To: Quinault Indian Nation

From: Natural Systems Design, Inc.

Re: Critical Review of Proposed Chehalis River Basin Flood Damage Reduction Project Draft SEPA EIS

Hydrology Technical Memo 1: OBSERVED AND PREDICTED FLOWS RELATIVE TO FRE FACILITY OPERATION

Figure 1. NOAA 2-day predicted streamflow vs. USGS 15-minute recorded streamflow at the Grand Mound Gage. Each point represents one timestamp. For a perfect model, in which predicted streamflow = observed streamflow exactly, all points would fall on the black 1:1 line.

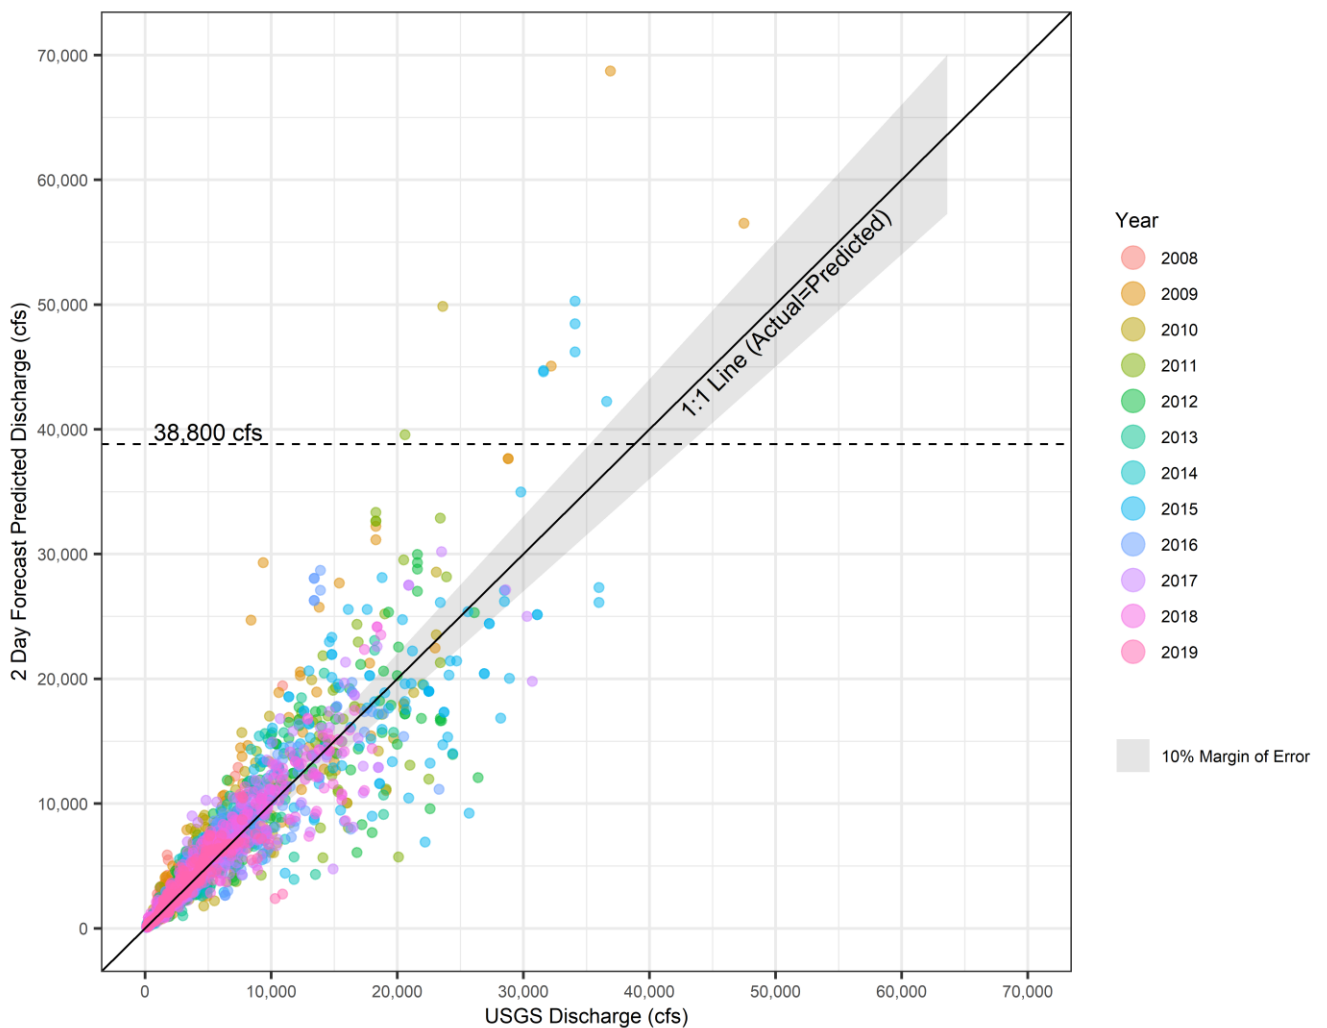
Figure 1 and Figure 2 illustrate the relationship between observed and predicted values at high flows for both the 2- and 4-day forecasts. For both forecasts, the points cluster around the 1:1 line near the origin, but the scatter increases as flow increases. Above 25,690 cfs (i.e. the 2-yr recurrence interval flow), the majority of points in the 2-day forecast (Figure 1) are well above the 1:1 line, indicating that the predicted value is greater than the observed value. In the 4-day forecast (Figure 2), the predicted values are well below the 1:1 line for flows greater than the 2-year recurrence interval, indicating that the predicted value is lower than the observed value.

These results demonstrate that impacts associated with FRE facility operation have not been accurately represented in the Draft SEPA EIS because the modeled streamflow values upon which operations are based do not accurately predict the observed flows used in the DEIS to determine impacts. The relationship between predicted and observed flows changes depending on how far out the forecast is, i.e., 2 days out the model predicts *higher* flows than end up being observed, 3 days out the model over and underpredicts with nearly equal frequency, and 4 days out the model flips to predicting *lower* flows than end up being observed. For example, the FRE facility would have likely been utilized in 2010 when the 2-day prediction of 49,850 cfs was made. However, that flood reached only 23,600 cfs and thus the FRE facility would have been utilized prematurely, impounding flows and affecting river and floodplain processes for a flood well below the 38,800 cfs described throughout the DEIS as the ‘trigger’ for activation of the facility.
